U.S. Serial No. 10/085,343 – Jeffrey J. Gratz  
Art Unit 3727 – Attorney Docket 273.018  
Response to October 12, 2004 Office Action  
Page 10

REMARKS

FIG. 9

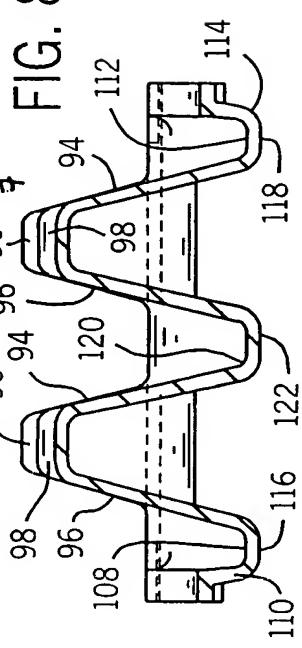
Referring to Fig. 9, a support structure is provided for supporting an object. The support structure includes an elongated member 50 extending along a longitudinal axis 51 and has first and second sides 52 and 54, respectively, first and second edges 56 and 58, respectively, and first and second ends 60 and 62, respectively. The first side 52 of the elongated member has a first plurality of ribs 64 projecting therefrom that are spaced between the first and second ends 60 and 62, respectively, along a first axis 51a. Each of the first plurality of ribs 64 are laterally spaced from the first edge 56. A second plurality of ribs 65 project from the first side 52 and are spaced between the first and second ends 60 and 62, respectively, along a second axis 51b. Each of the second plurality of ribs 65 is laterally spaced from the second edge 58. A plurality of depressions 120 are formed in first side 52 and are spaced between the first and second ends 60 and 62, respectively, along a third axis 51 disposed between the first and second axis 51a and 51b, respectively. Each of the plurality of depressions 120 are between one of the first plurality of ribs 64 and one of the second plurality of ribs 65 and form a corresponding rib projecting from the second side 54 of the elongated member. The ribs project from the second side 51 of the elongated member and are spaced between the first and second ends 60 and 62, respectively, along the third axis 51. The ribs projecting from the second side 54 of the elongated member include a first rib 126 and a second rib 122. The first rib 126 and the second rib 122 defining a second side object receiving cradle 138 therebetween. The first plurality of ribs projecting from the first side 52 of the elongated member includes a first rib 68 and a second rib 88. The first rib 68 and the second rib 88 partially define a first object receiving cradle 132 therebetween. The first object receiving cradle 132 opens in a first direction and the second side object receiving cradle 138 opens in a second direction opposite to the first direction.

FIG. 10

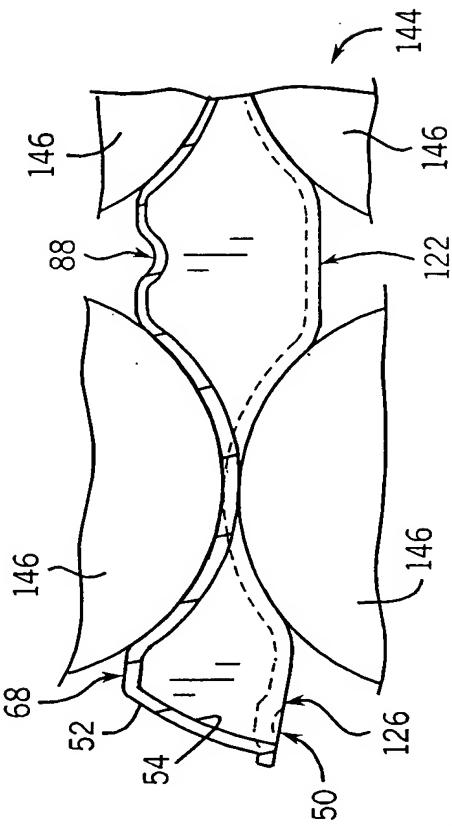
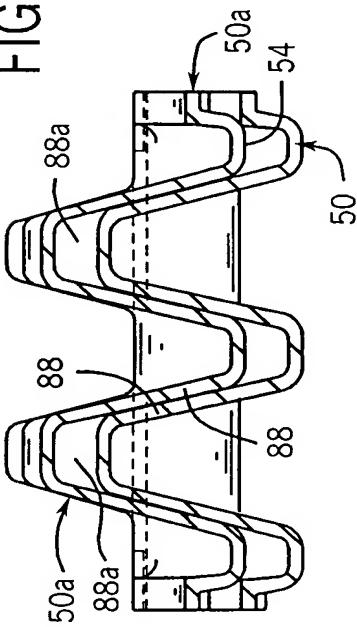
Initially, it is noted that the Examiner has objected to the drawings due to applicant's alleged failure to identify certain axes recited in the claims. As previously indicated to the Examiner, the claims refer to no less than ten various potential axes. However, applicant has amended the specification, as well as, Figs. 4 and 12 in order to identify the axes recited in the claims. Replacement sheets and annotated sheets identifying such changes to the drawings in red are provided herewith. No new matter is provided.
